# CITY OF DE PERE

ADDENDUM NO. 1  
PROJECT 23-16  
BRIDGE REHABILITATION

WING STRAPPING

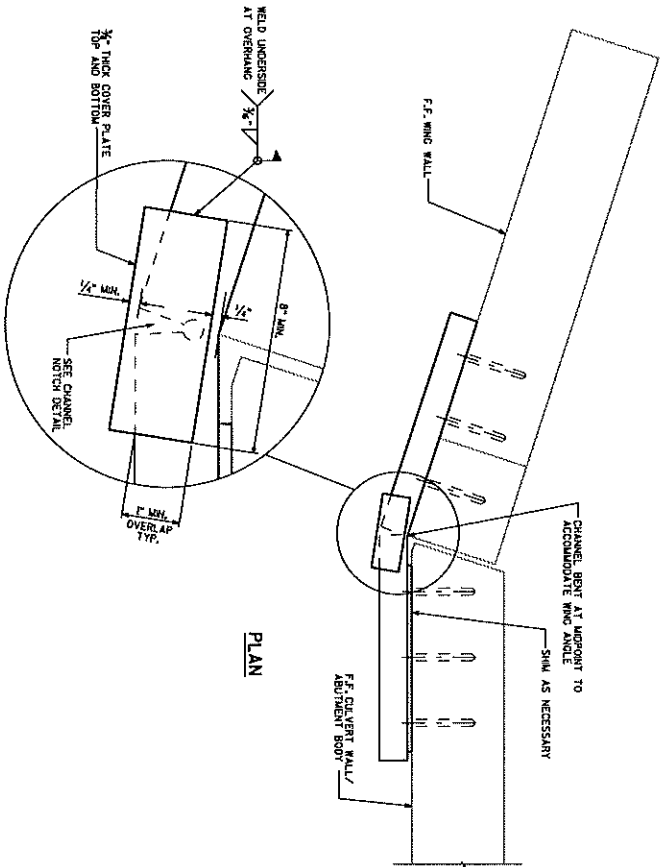
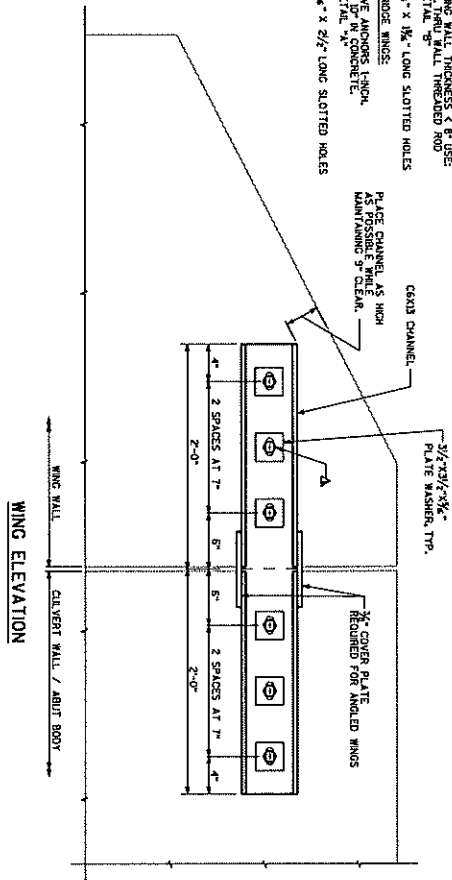
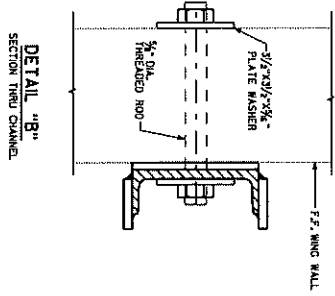
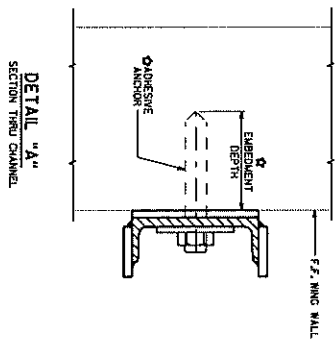
1. Appendix A, Page 4 of the plan details, delete the "Wingwall Banding Detail" and insert the attached "Wing Strapping" detail from the Wisconsin Department of Transportation as the fifth page in Appendix A.

FOR CLVERT WINGS:  
WITH WING WALL THICKNESS 2' USE:  
ADHESIVE AMONGS 3/4" INCH  
SEE DETAIL "A"  
WITH WING WALL THICKNESS 4' USE:  
ADHESIVE AMONGS 1" INCH  
SEE DETAIL "B"  
USE 1/2" x 3/4" LONG SLOTTED HOLES  
FOR BRIDGE WINGS:  
ADHESIVE AMONGS 1" INCH  
SEE DETAIL "A"  
USE 1/2" x 2 1/2" LONG SLOTTED HOLES

**NOTES**  
WING STRAPPING DETAIL FOR THE PURPOSE OF LATERAL INWARD OR WING REINFORCEMENT AT TERMINAL TO THE PROVIDED METHOD OF WING REINFORCEMENT.  
NO JUDY SHALL BE "STRAPPING 8-XX-XX" WHICH INCLUDES ALL ITEMS SHOWN.  
ALL PROVIDED STEEL MATERIAL SHALL CONFORM TO ASTM A36.  
ALL STRUCTURAL STEEL SHOWN SHALL BE GALVANIZED, THERMOPLASTIC COATED OR GALVANNEAL.  
CUTTING AND DRILLING OF CHANNEL SHALL BE DONE IN FABRICATION SHOP PRIOR TO GALVANIZING.  
IF WELDING COVER PLATE IN FIELD PRIOR TO WELDING BRIDGE GALVANIZING FROM AREA TO BE WELDED, TOUCH UP WITH PAINT ALL AREAS LACKING GALVANIZING WHEN COMPLETE.  
CALCULATE AROUND PERIMETER OF CHANNEL AND FILL PORTION OF HOLE AROUND ANCHOR BOLT AND SHIM WITH NON-STAINING GRAY NON-BRANDED SPACKLING.  
ADHESIVE AMONGS SHALL CONFORM TO SECTION 502.212 OF THE STANDARD SPECIFICATIONS.
